GENOA CHARTER TOWNSHIP BOARD

Regular Meeting

July 17, 2023

TO: Honorable Board of Trustees
FROM: Amy Ruthig, Planning Director
DATE: July 11, 2023
RE: Legacy Apartments - Dorr/Grand River Ave. Final RPUD PUD

NOT FOR CONSTRUCTION **C-2.1**

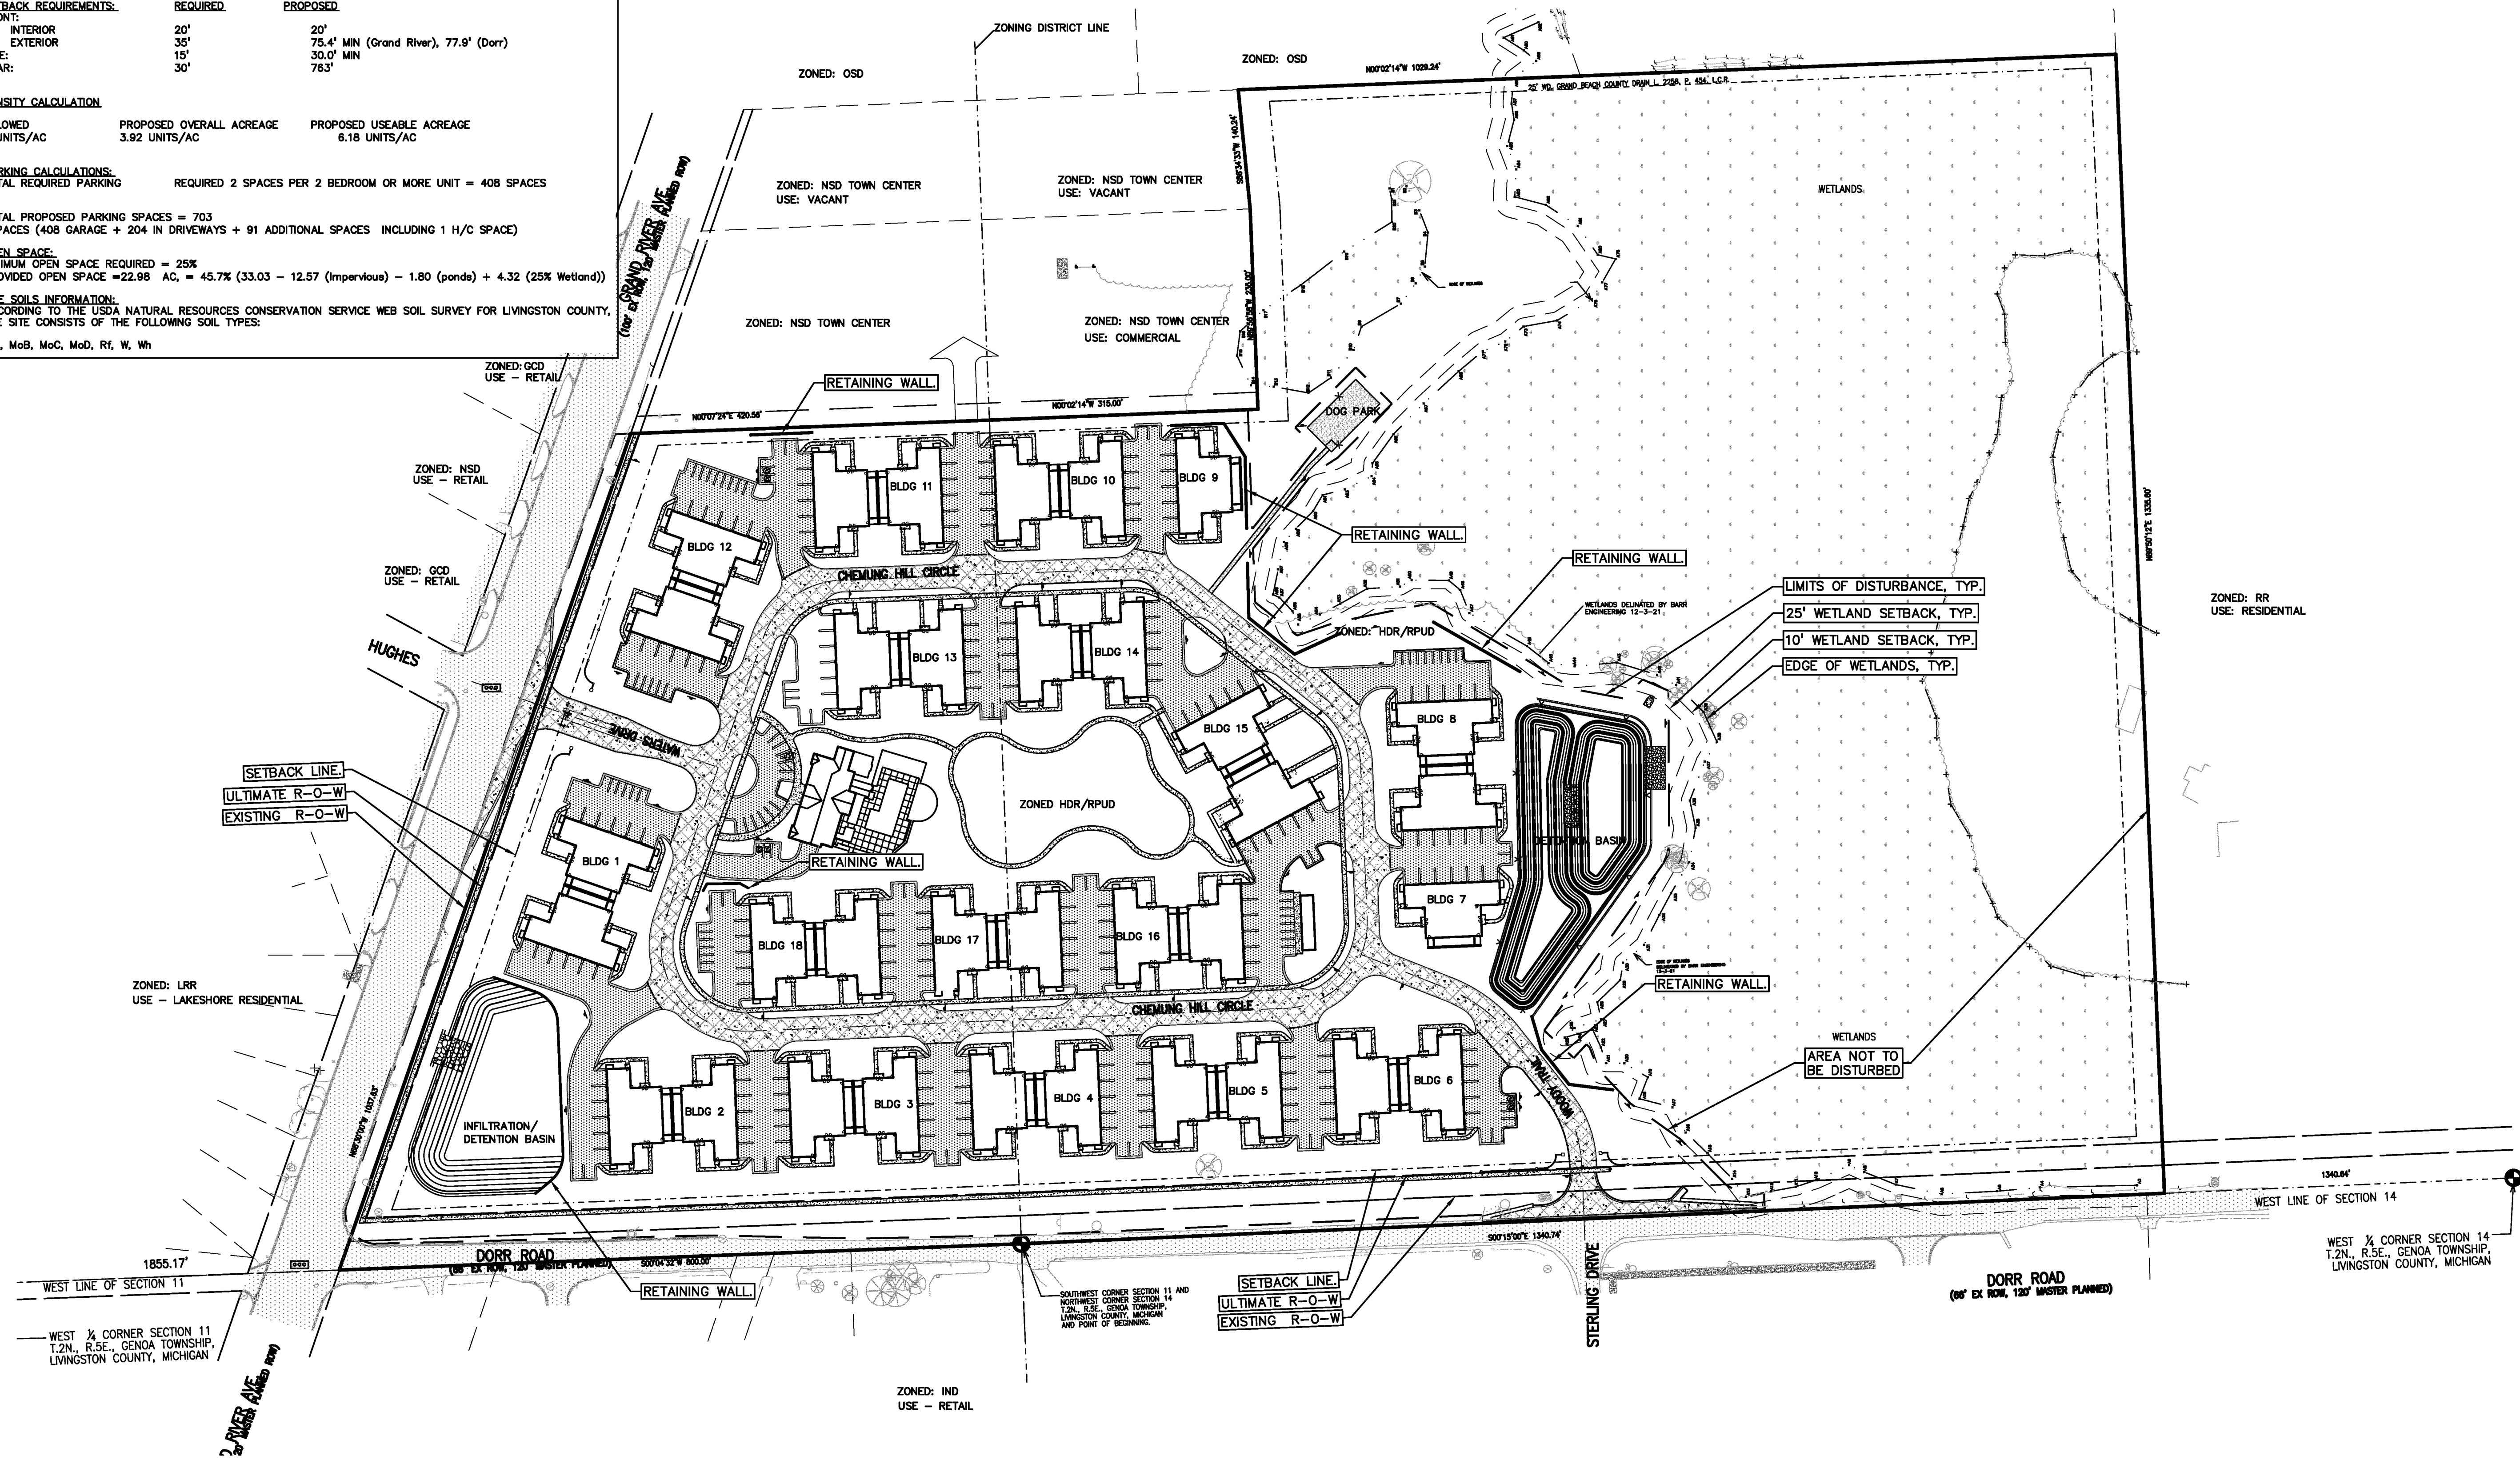
- 9. Refuse Removal.** A note on Sheet C-2.1 states that “trash collection will be provided via individual trash carts for each unit with curb side trash collection.”

NOT FOR CONSTRUCTION **C-2.2**

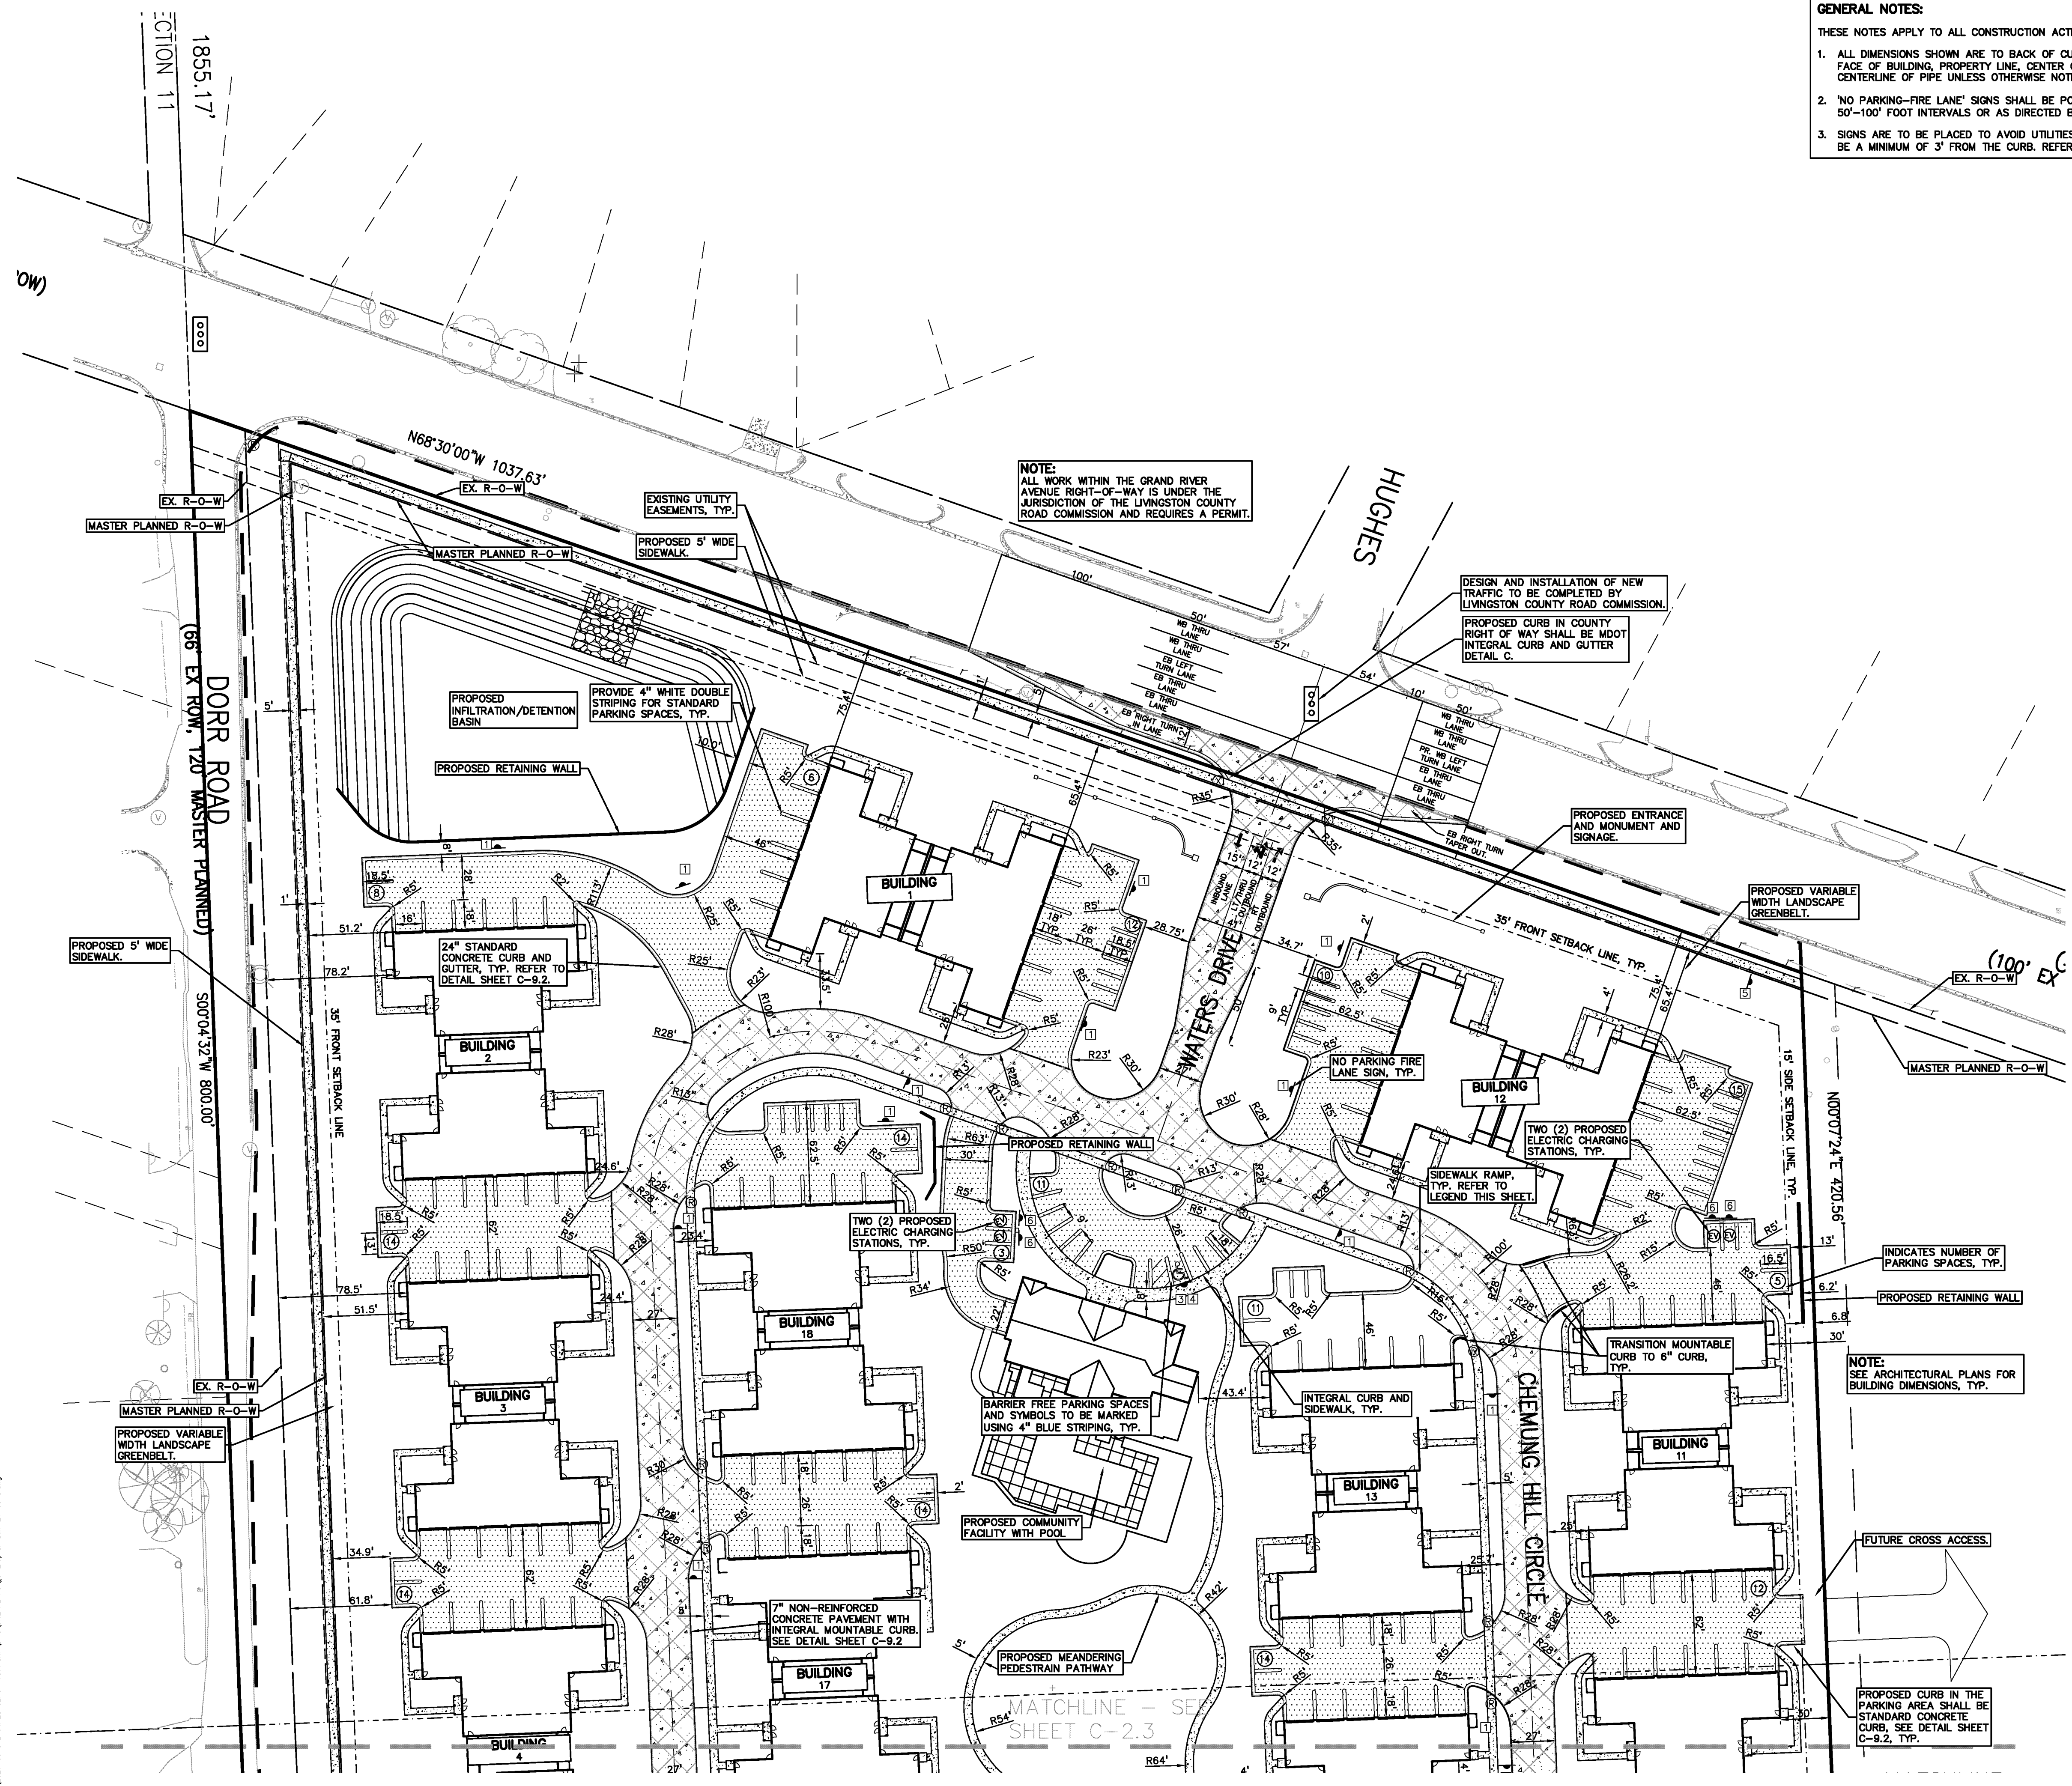
The traffic study recommends an upgraded traffic signal at the Grand River and Hughes intersection. A note on Sheet C-2.2 indicates that design and installation of the new signal will be completed by the Road Commission.

C-3.2

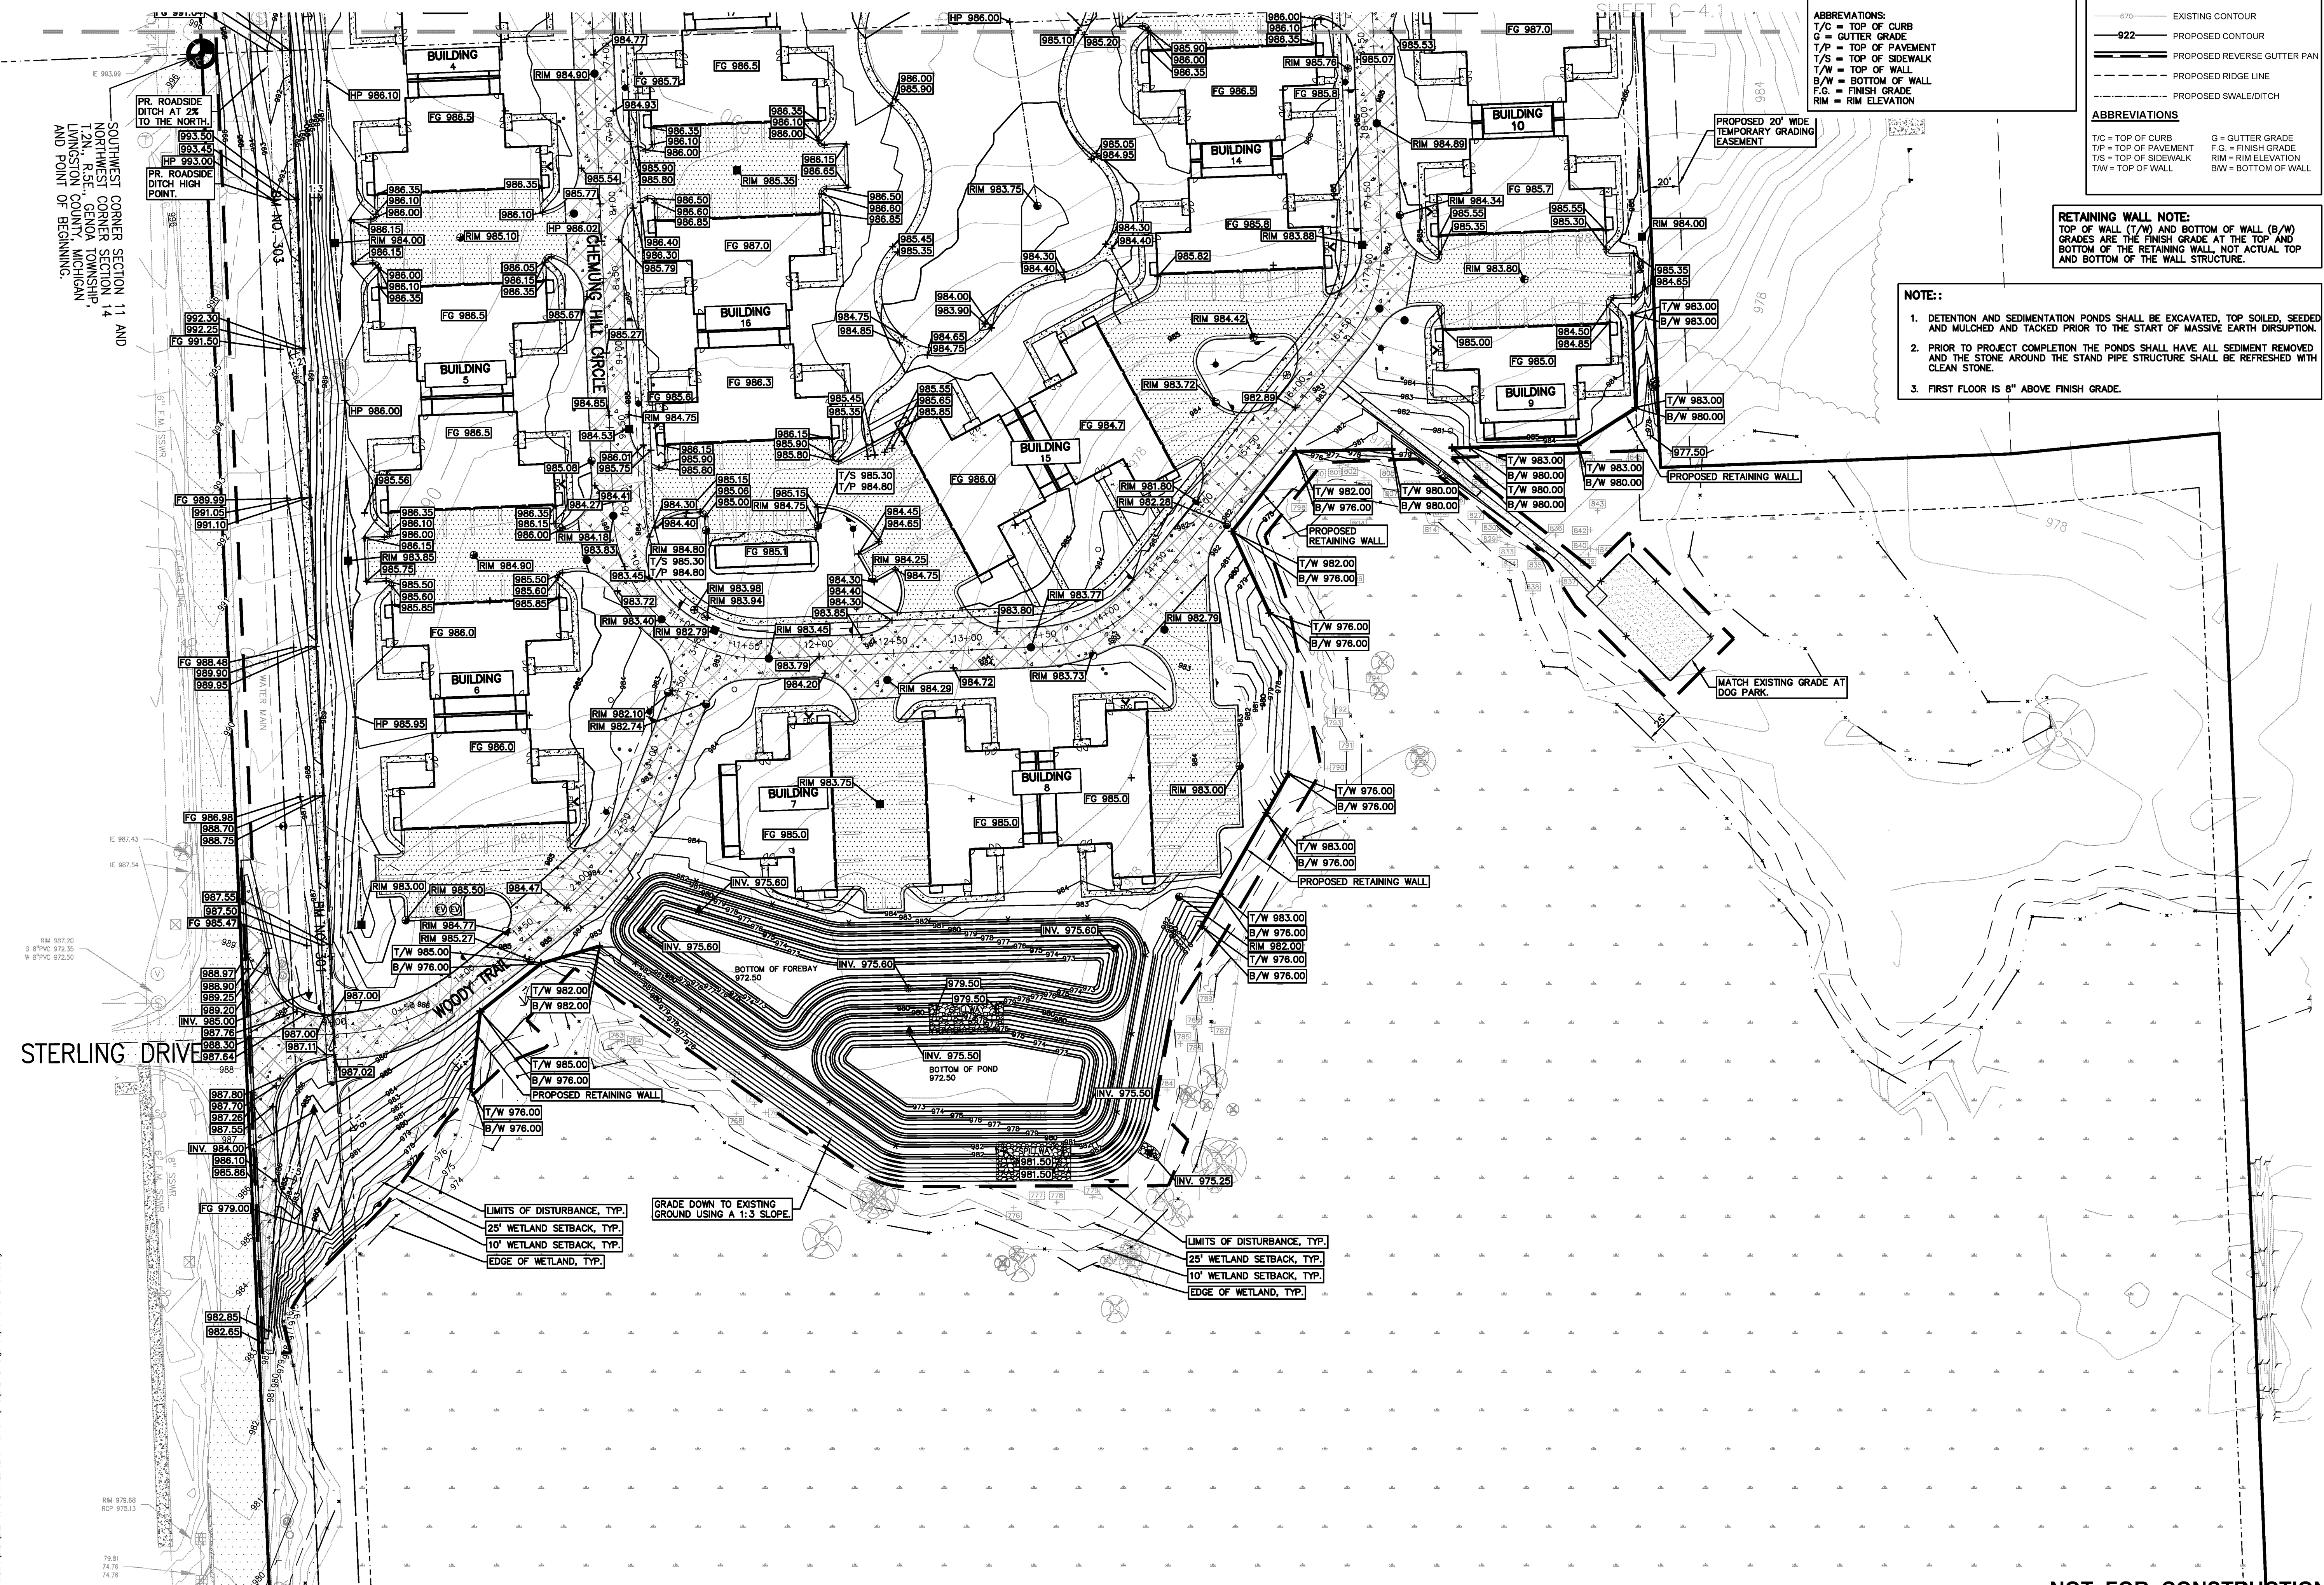
7.) Site Grading - A pavement high point elevation should be shown between CB 30E and CB 32A on Sheet C-3.2. A complete review of the proposed site grading design will be performed at the time of the project's Construction Plan submittal which should address the following additional grading related items:
